NOTICE OF ADDENDUM

ADDENDUM NO. 4

CONTRACT NO. 7528, PROJECT NO. 10305 NAKOOSA TRAIL FLEET/FIRE/RADIO SHOP FACILITY

PARTIAL ENLARGED LOW ROOF FRAMING PLAN AREA A
1/4" = 1'-0"

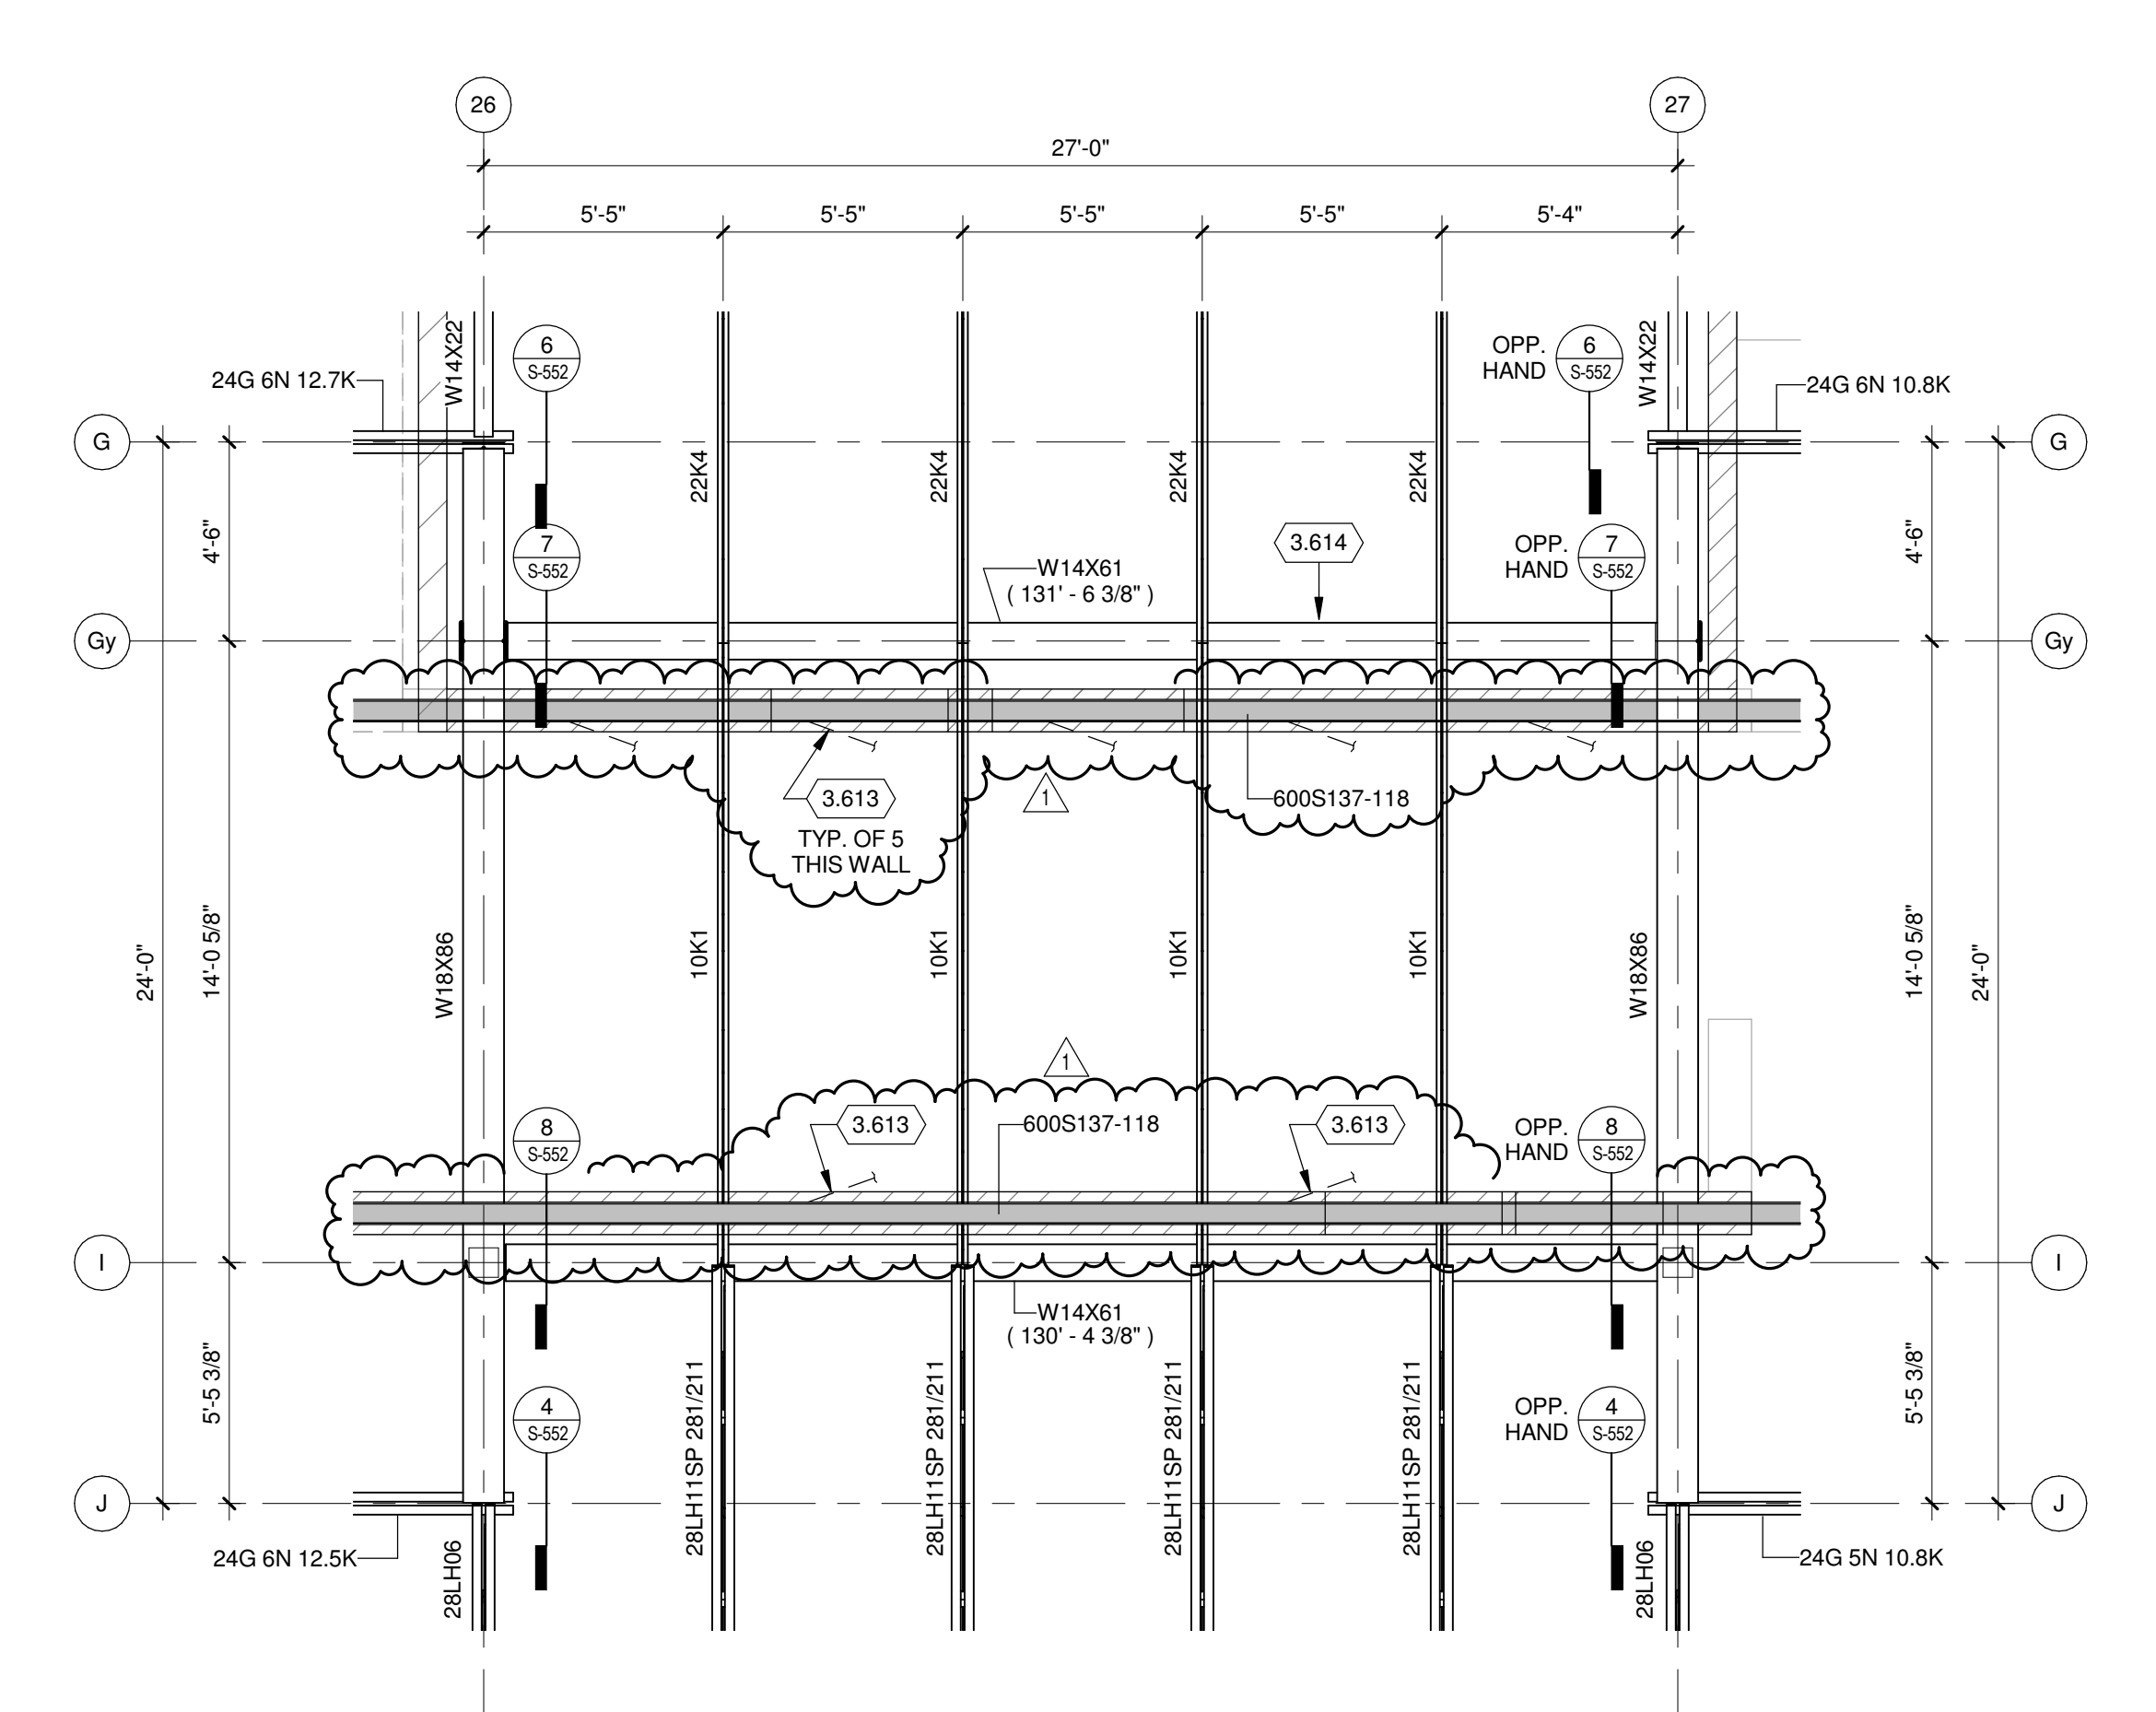
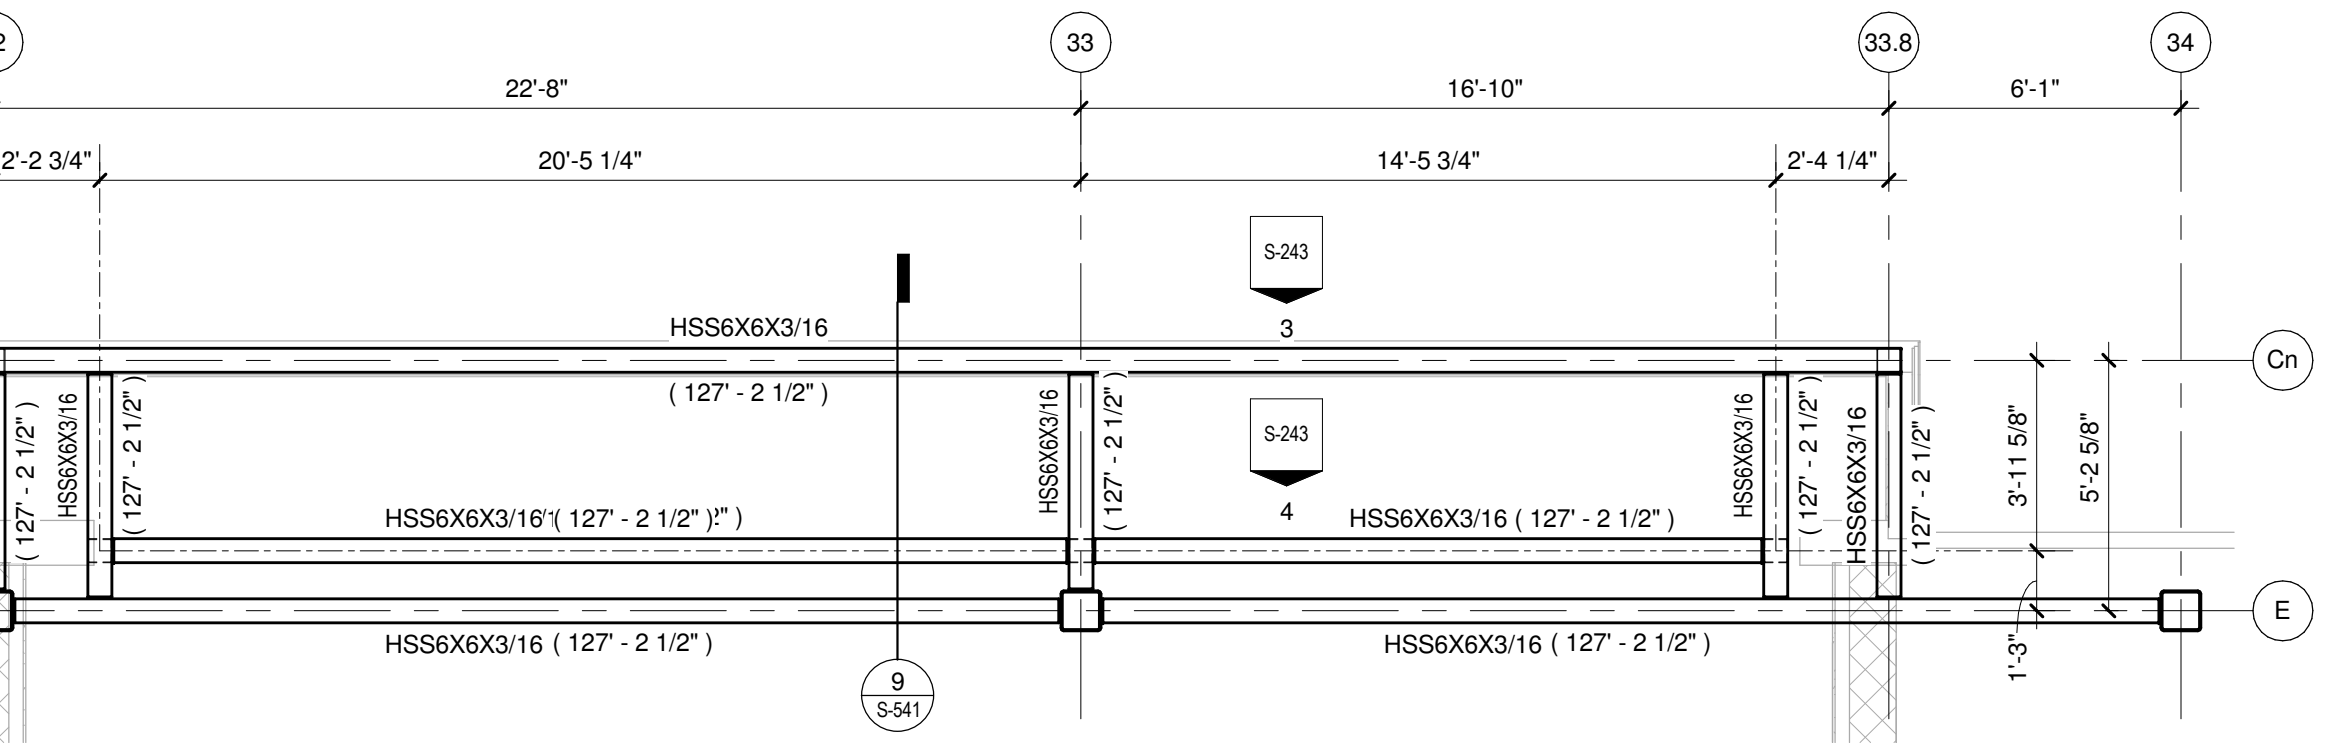
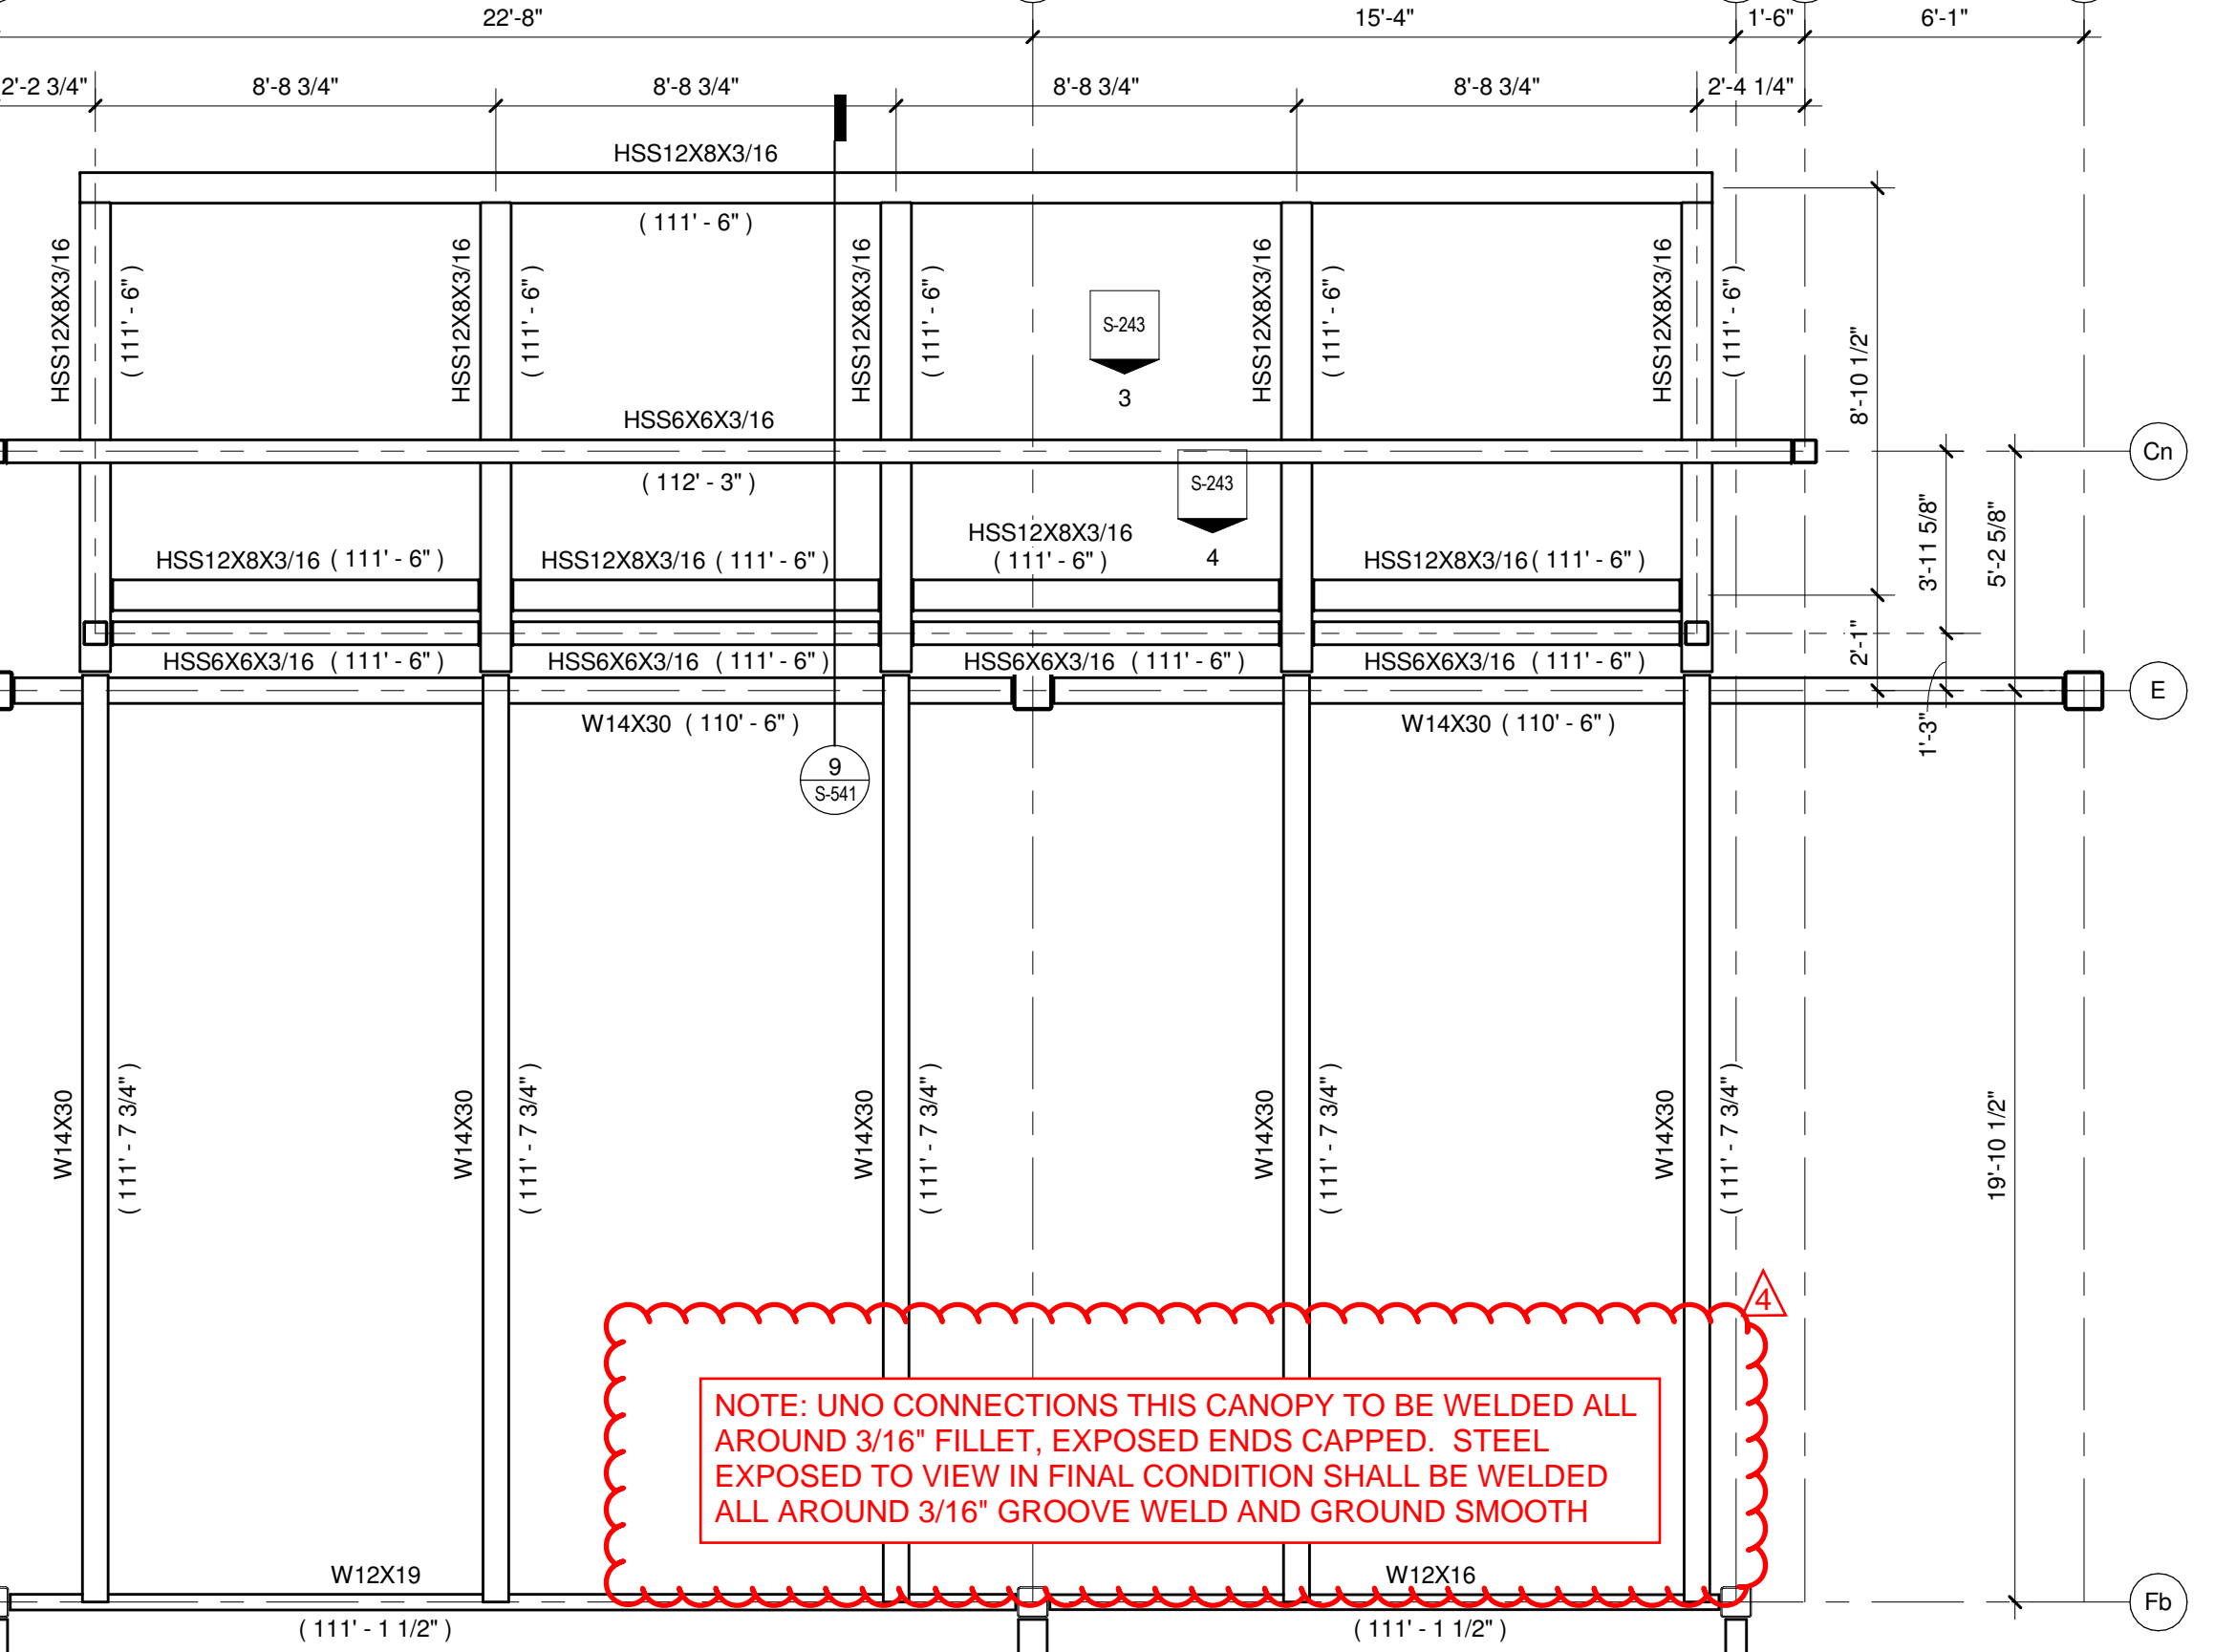
- A. **MODIFIED** A-126 MISC ROOF PLANS with markups of support angle locations at the intermediate sidelap of MS-3 perforated panels. See attached drawing sheet.
- B. **MODIFIED** A-510 CANOPY DETAILS with support angle at intermediate sidelap of perforated panels.
- C. **MODIFIED** S-451 MISCELLANEOUS FRAMING PLANS. See attached drawing sheet.
- D. **MODIFIED** S-601 STRUCTURAL SCHEDULE Add structural column schedule general note:
1. ALL BASEPLATES ARE 3/4" THICK UNO. (Drawing sheet not attached.)
